SUBJECT: City of San Diego Master Storm Water System Maintenance Program (MMP)
Substantial Conformance Review for Upper and Lower Alvarado Creek Channel
Maintenance Project; MMP Maps 59, 60 and 64

Subject: DSD/MSCP cycle review issues for Alvarado Channel maintenance

Subject: 2010-2011 Alvarado Channel Emergency Maintenance Impact and Mitigation Update

ALVARADO CREEK VEGETATION IMPACTS WITH MHPA

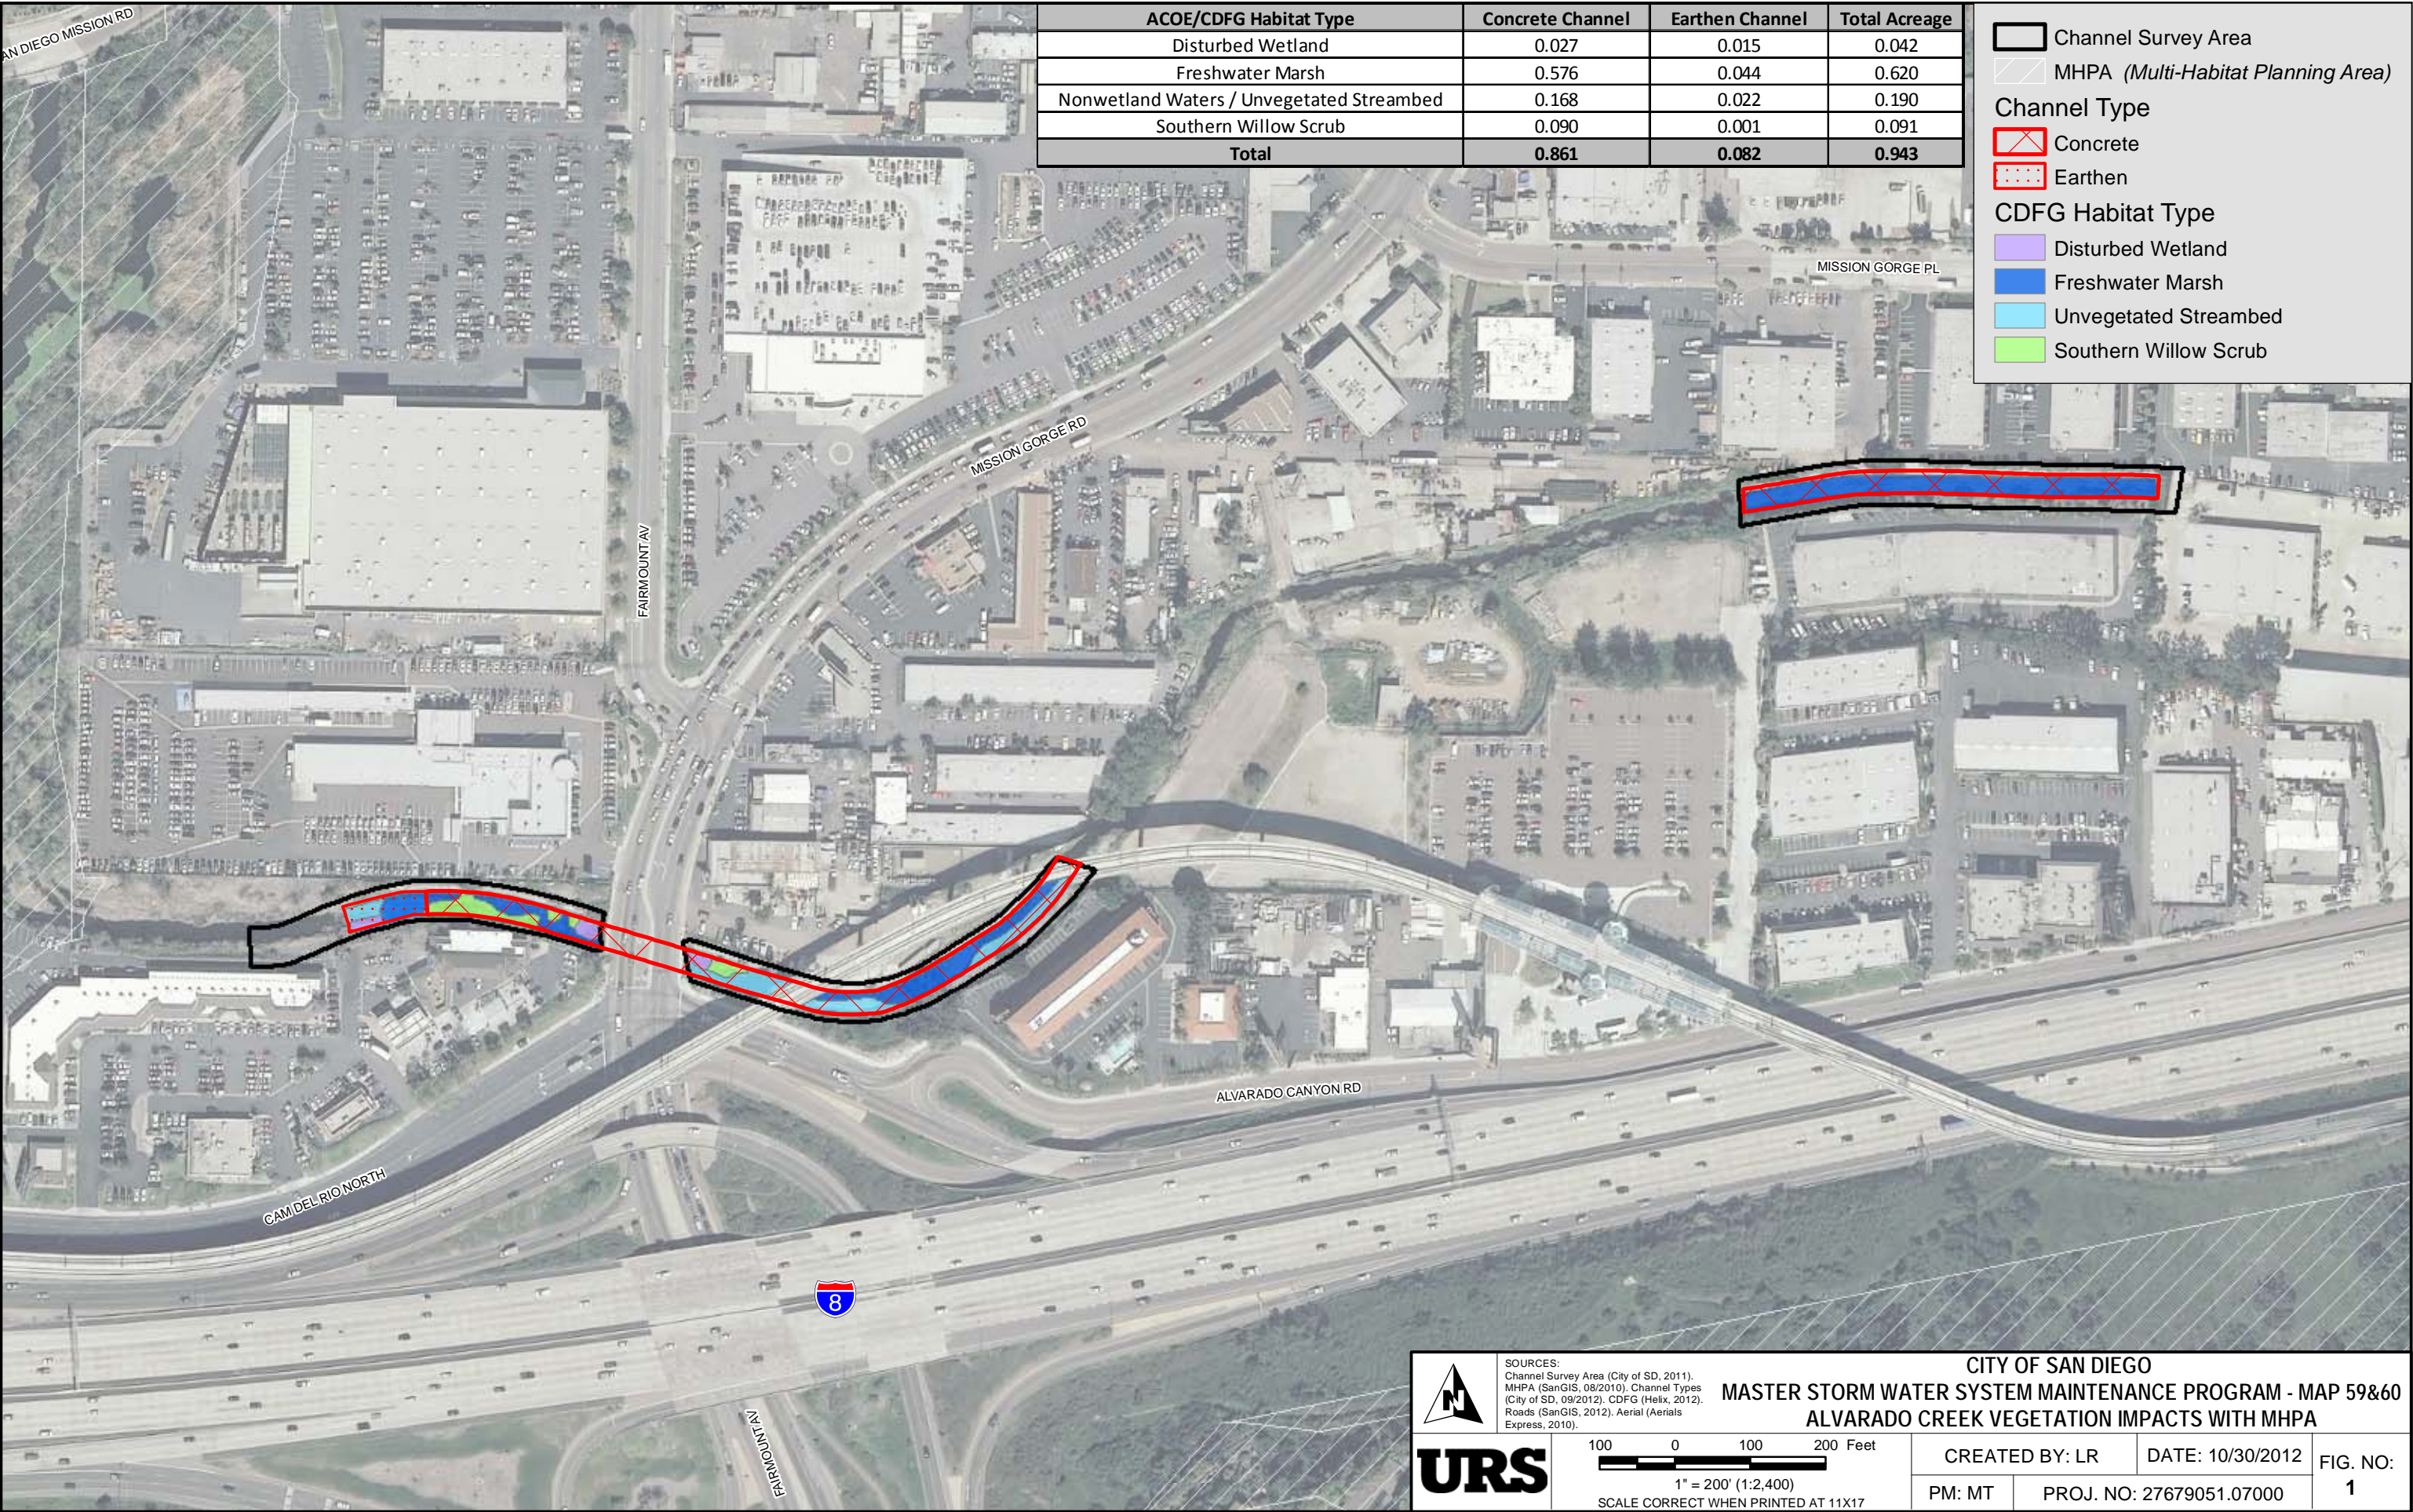
Issue 1: *The project site lies partially within the Multi-Habitat Planning Area (MHPA of the City's MSCP (Map 59 and 64). Please provide a map of the MHPA boundary on the project plans at the same scale as the project or a maximum scale of 1":200'. This map should also be provided in the biological survey report. In addition, please identify any MHPA guidelines, as described in the MSCP Subarea Plan, that apply to the site and any management conditions that would apply to the areas conserved as MHPA open space.*

On Map 64 (Figure 2), the MHPA boundary intersects the maintenance area at its eastern end along approximately 200 feet of the channel. Most of this section of the channel is concrete bottomed but did contain small areas of freshwater marsh and other wetland habitats. The extent and vegetation types impacted are shown on Figure 2. The total area of wetland impacts within the MHPA boundary is 0.11 acres.
